**SUSQUEHANNA STEAM ELECTRIC STATION
SUPPLEMENTAL INFORMATION APPLICABLE
TO PROPOSED AMENDMENT NO. 235 TO
LICENSE NPF-14 AND PROPOSED AMENDMENT
NO. 200 TO LICENSE NPF-22: POWER UPRATE
PLA-5300**

**Docket No. 50-387
and 50-388**

The purpose of this letter is to respond to your Request for Additional Information (RAI) [Reference 1] and to describe changes to the power ascension test regime delineated in reference 1.

OVERPRESSURE PROTECTION ANALYSIS
 (MSIV CLOSURE WITH HIGH FLUX SCRAM TRIP)
 FSAR FIGURE 5.2-14

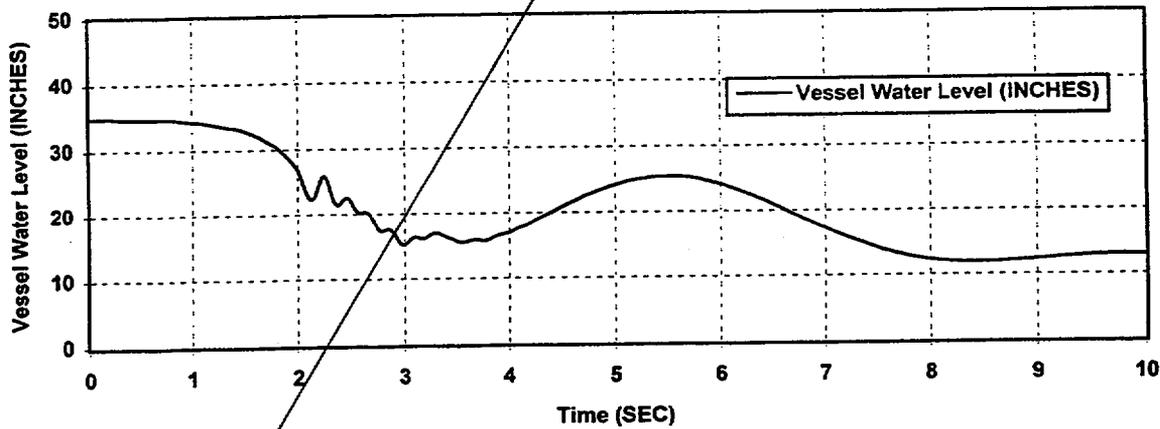
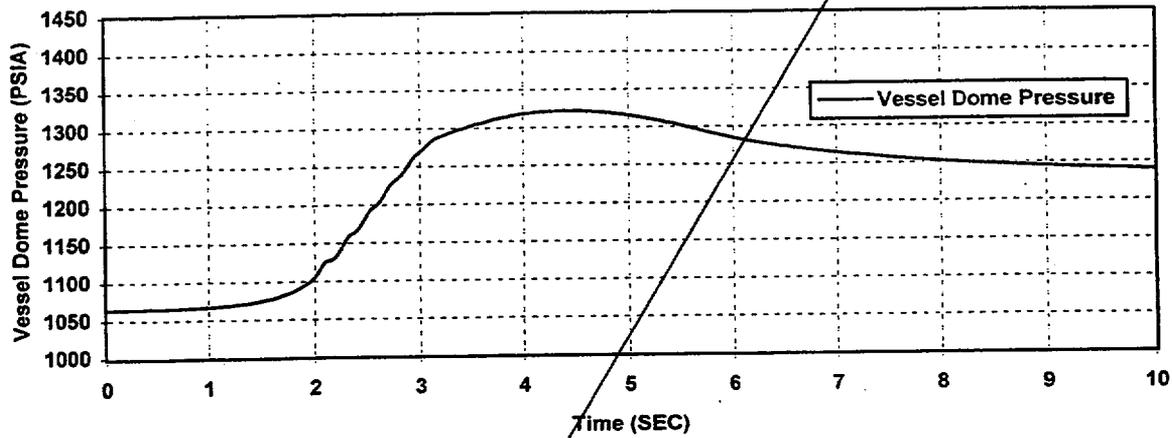
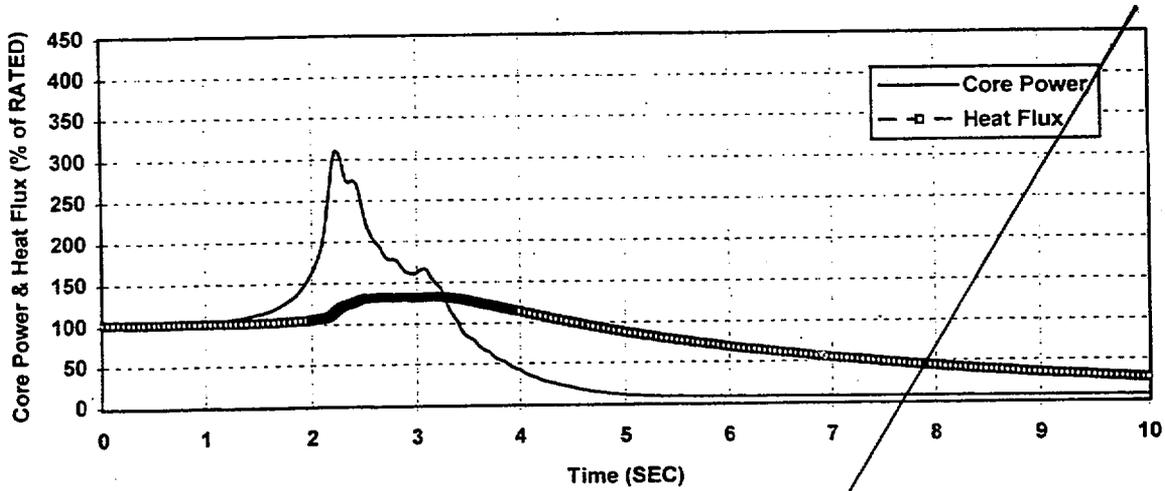
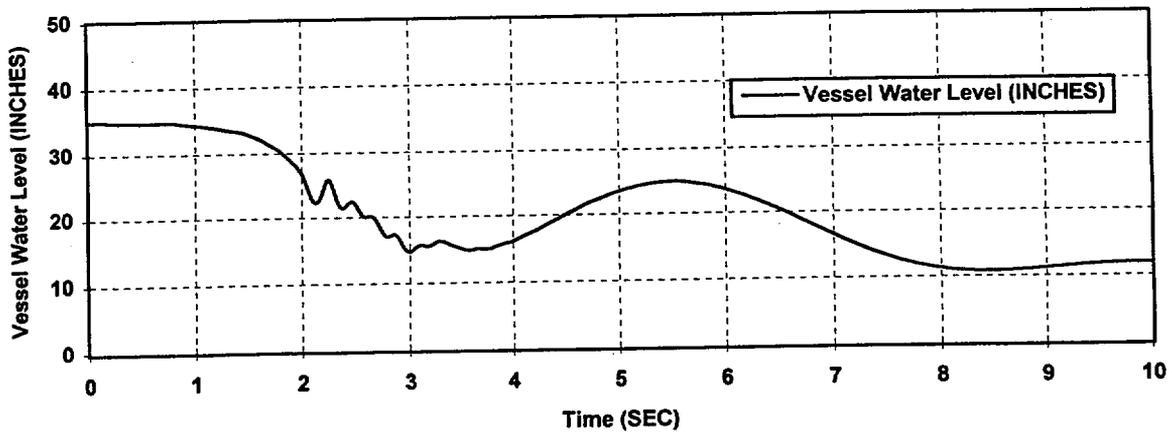
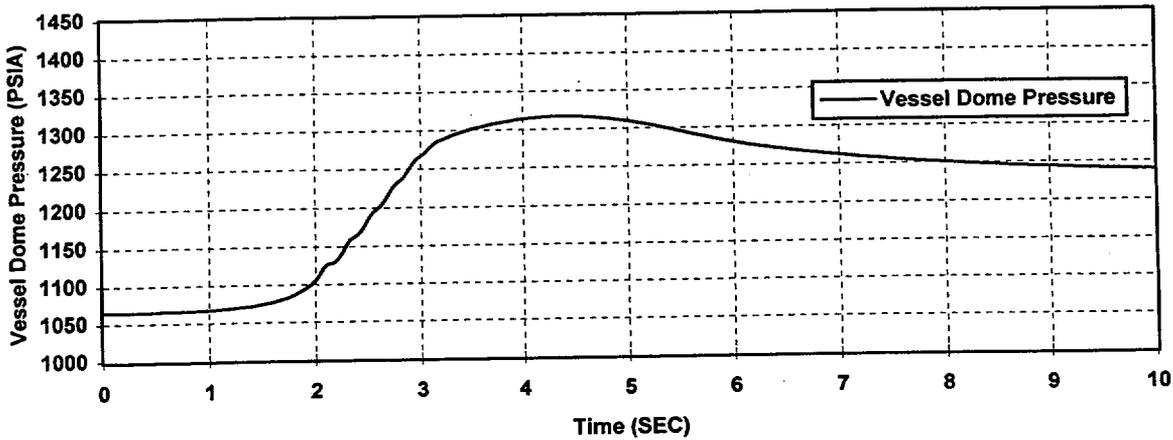
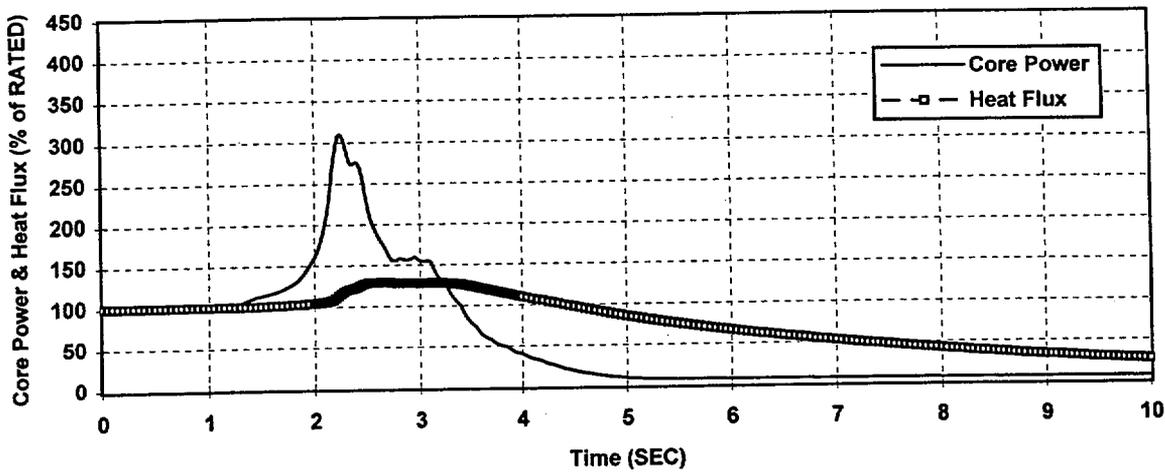
You stated in your submittal that because the uprated power does not entail an increase in the operating pressure used for evaluation, the SRV pressure setpoints do not have to be changed. Please verify that the SRV's can provide the necessary overpressure protection during limiting anticipated operational occurrence transients, ATWS transients, and American Society of Mechanical Engineers (ASME) overpressure transients.

Transient Overpressure (TOP) analysis, performed specifically for Unit 2 Cycle 11 at the uprated conditions, is documented in draft updates to Chapter 5.2 of the FSAR contained herein. This analysis demonstrates that the SRV's provide the necessary overpressure protection with respect to the TOP limits. In addition, Chapter 15 analysis has also been performed specifically for Unit 2 Cycle 11 operation at the uprated conditions, and results meet all criteria set forth in Chapter 15. Therefore, SRV setpoints do not require revision due to operation at a licensed power level of 3489 MWt.

Replace figure
